SUBJECT: IN THE MATTER OF 238 NUCLEAR ISLAND
GENERAL ELECTRIC STANDARD SAFETY ANALYSIS REPORT (GESSAR II)
DOCKET NO. STN 50-447

Reference: Letter from G.G. Sherwood (GE) to D.G. Eisenhut (NRC)
pertaining to draft responses to the Commission's
August 25, 1982 request for additional information on
GESSAR II, dated November 10, 1982.

DRAFT RESPONSES TO
RADIATION ASSESSMENT BRANCH
QUESTIONS

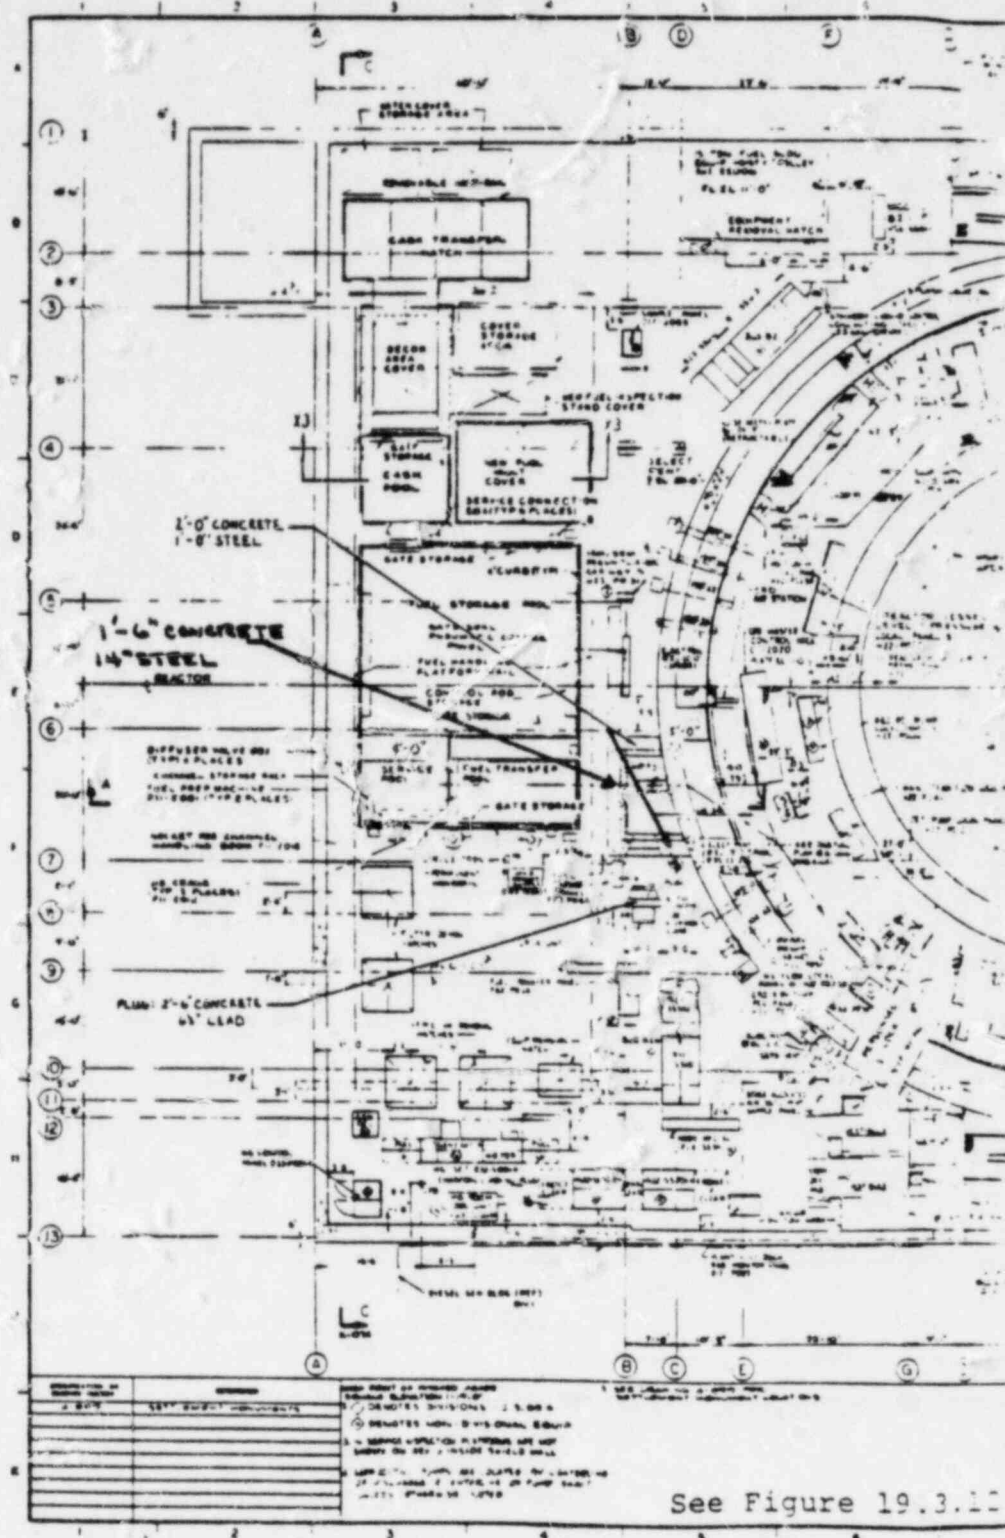
In Section 12.3.2.3 of your FSAR, you state that access to the fuel transfer tube is through a hatch shielded by a stepped composite concrete and lead shield plug. It is our position that all accessible portions of the plant near the spent fuel transfer tube and/or canal must be shielded during fuel transfer. Refer to our position in Section C.2.a of Regulatory Guide 8.8 which states that extraordinary design features are warranted for very high radiation areas. Using removable shielding for this purpose is acceptable. In this regard, the removable shielding shall be such that the resultant contact radiation levels shall be no greater than 100 rads per hour. All accessible portions of the spent fuel transfer tube shall be clearly marked with a sign stating that potentially lethal radiation fields are possible during fuel transfer. If removable shielding is used for the fuel transfer tubes, it must also be explicitly marked as described above. It is our position that if permanent shielding is not used, local radiation monitors capable of providing audible and visible alarms must be installed to alert personnel when the temporary fuel transfer tube shielding is removed during fuel transfer operations. Accordingly, provide the following additional information:

- c. Indicate the thickness of the spent fuel transfer tube shielding on Figure 19.3.12.3-6 of your FSAR at the 26.5 foot elevation.

- d. Provide a description of your proposed shielding and access controls for access to the fuel transfer tube valve room in the annulus area. (annulus access at elevation 11'-0", Figure 19.3.12.3-6)

The concrete shielding dimensions of the spent fuel transfer tube shielding are shown on revised Figure 19.3.12.3-6.

See revised subsection 12.3.2.3 and Figure 19.3.12.3-3.

AN INTERLOCK IS PROVIDED TO PREVENT SPENT FUEL PASSAGE WHEN EITHER OF THE SHIELD PLUGS, AT 11 FOOT OR 26 FOOT ELEVATION, ARE NOT CLOSED AND LOCKED.

FIGURE
11.2-1b
GESSAR

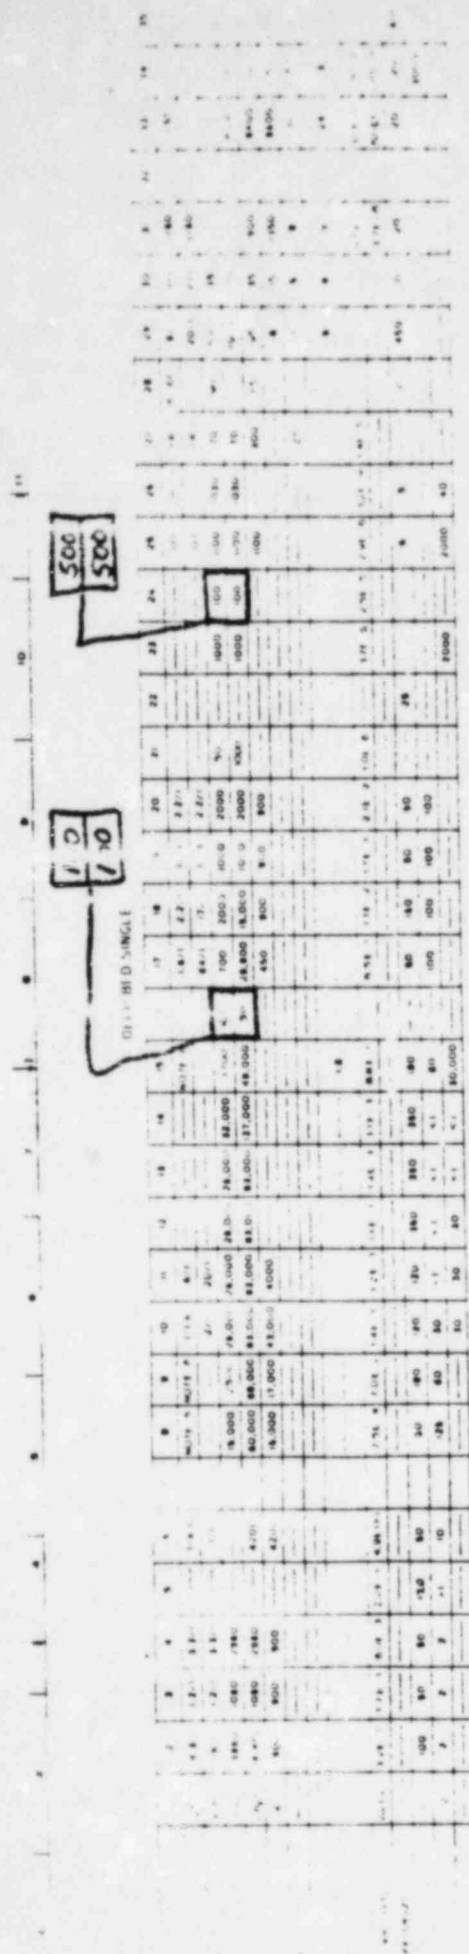
- b. Your inputs for chemical laboratory waste, laboratory wash water and laundry drains are low in comparison with the corresponding values given in NUREG-0015, Revision 1, on a per reactor basis. Verify and correct, as appropriate, these inputs.

SECTION H-H

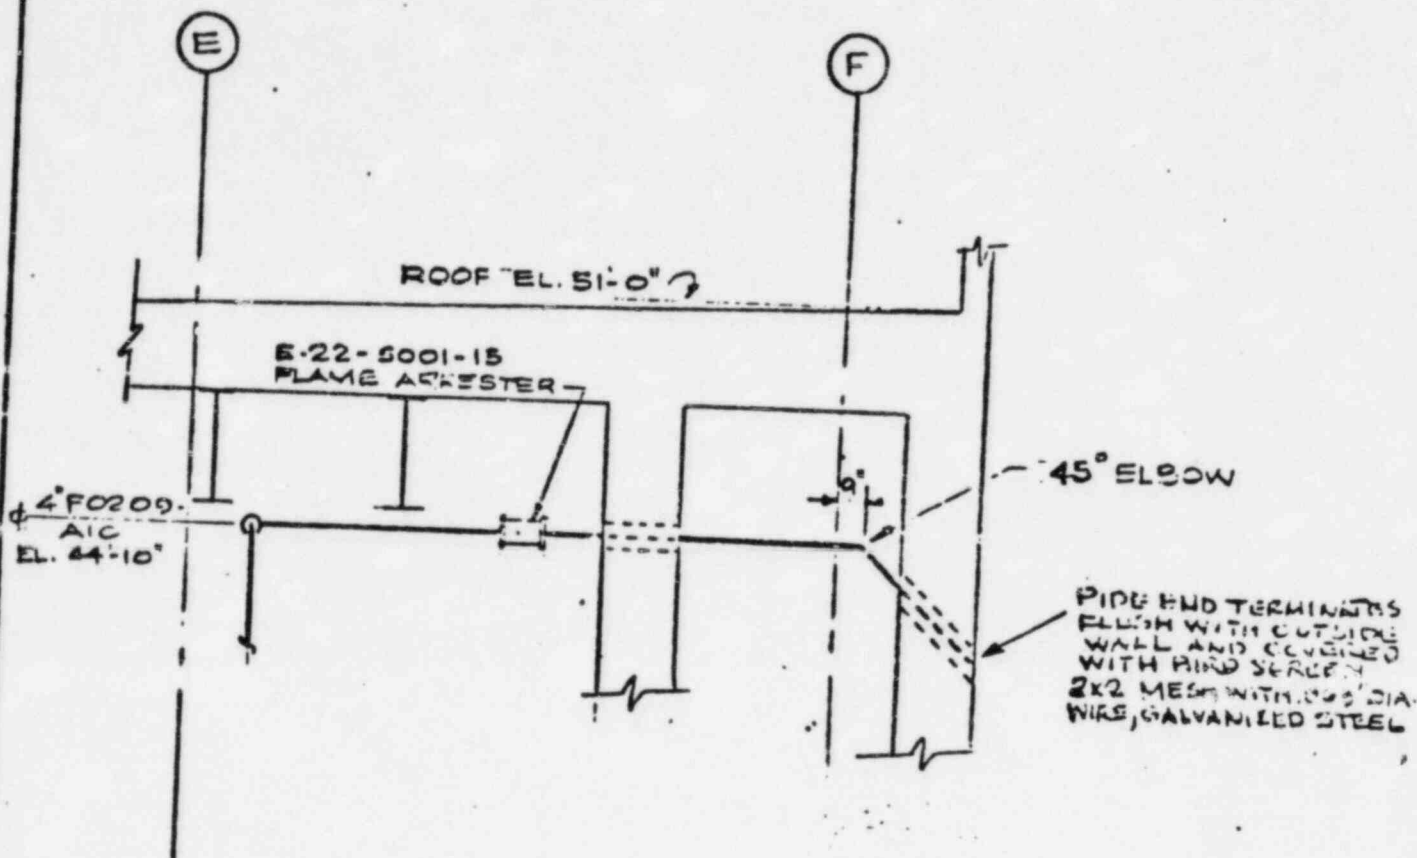
You show on Figures 9.5-10 and 9.5-11 of your FSAR, the day tank vents terminating somewhat outside the diesel-generator room. However, it is not clear from Figures 9.5-10 and 9.5-11 nor from Figures 1.2-18 through 1.2-22 of your FSAR, exactly where the Divisions 1, 2, and 3 day tank vents terminate. Accordingly, provide additional information on these vents. Show vent the terminations on appropriate views in Figures 1.2-18 through 1.2-22 of your FSAR and provide details of the terminations which show that they are protected from tornados, floods and the effects of severe weather conditions.

Division 1 and 2 day tank vents terminate 6-inches beyond building wall into the dock area. These terminations are protected by the roof over the dock area and by the wall around the dock area. Division 3 vent terminates on a 45 degree down slope at the outside surface of the Diesel Generator Building wall. Bird screens cover all three terminations. All three terminations will be located on drawing K-036 (Figure 1.2-19) and the attached Section H-H added to drawing K-037 (Figure 1.2-20).

Figure 9.5-10. Division 1 and 2 Diesel Fuel Transfer, Intake and Exhaust System P&I Diagram

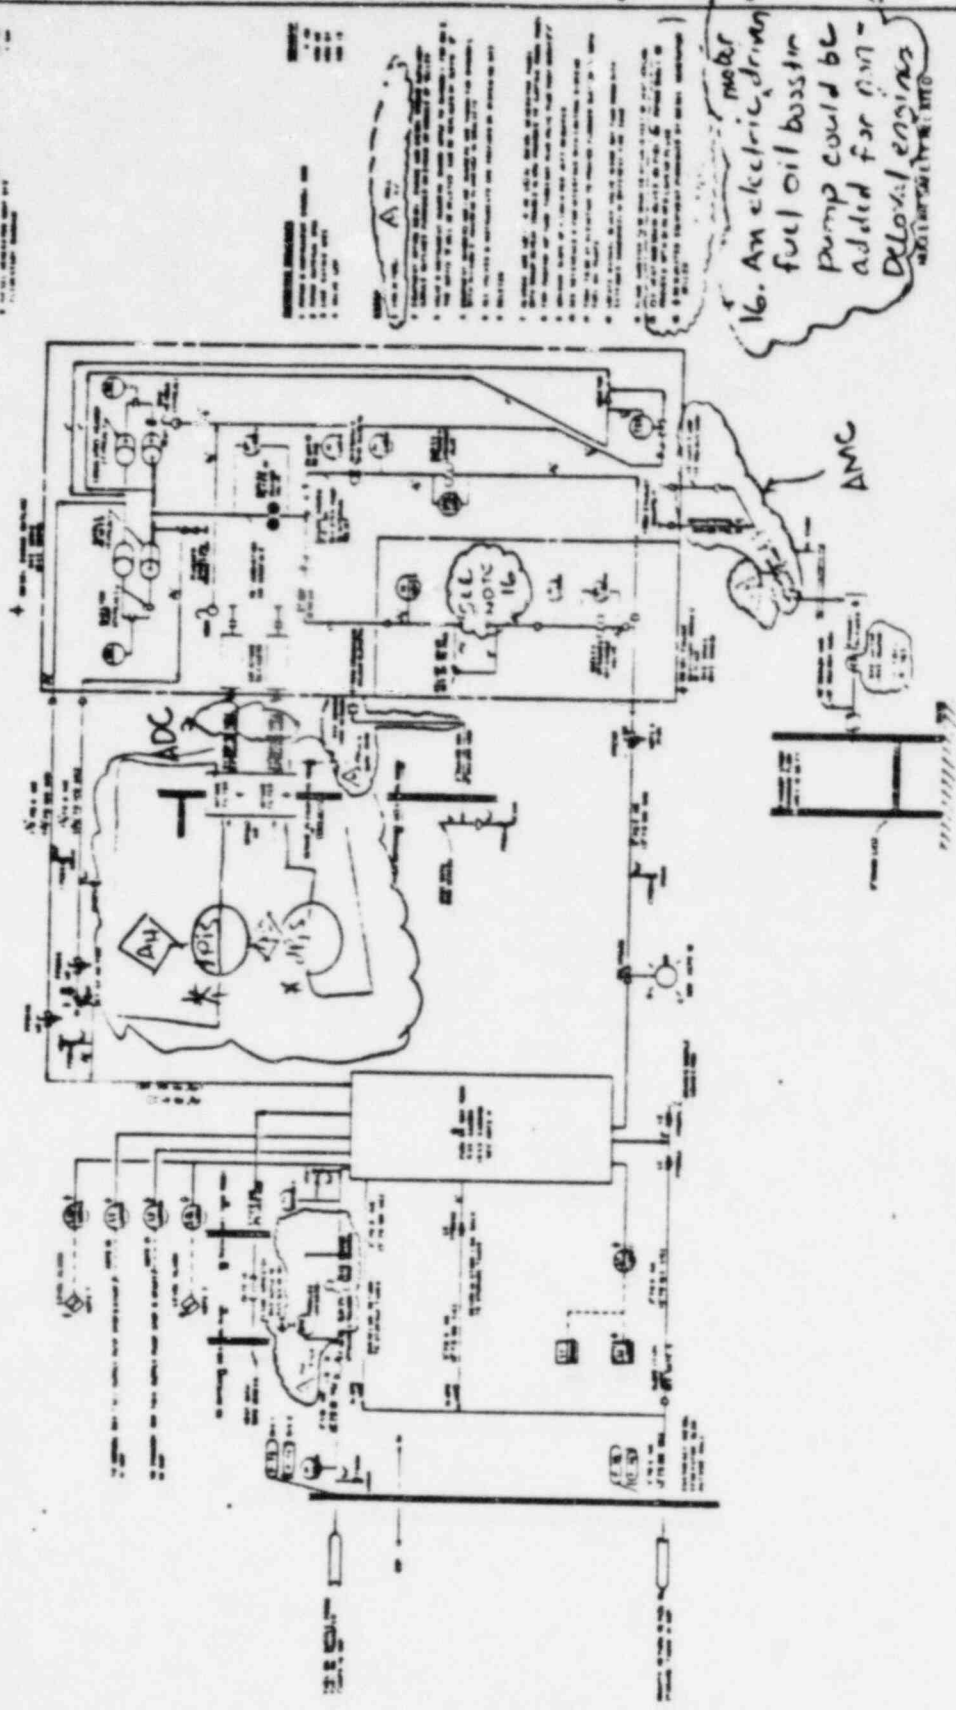
Revise Figure 9.5-10 of your FSAR, to show the complete combustion air intake and exhaust systems. Alternatively, provide a new P&I diagram showing these systems, including all three divisions. Show all instrumentation and controls associated with the systems.

The combustion air intake and exhaust systems shown in Figure 9.5-10 is complete. All instrumentation and controls associated with the systems but are not shown are by applicant. A differential pressure gauge across each filter including high differential alarm will be added to Figure 9.5-10 as shown on the attached marked up in 430.66. See response to 430.112.
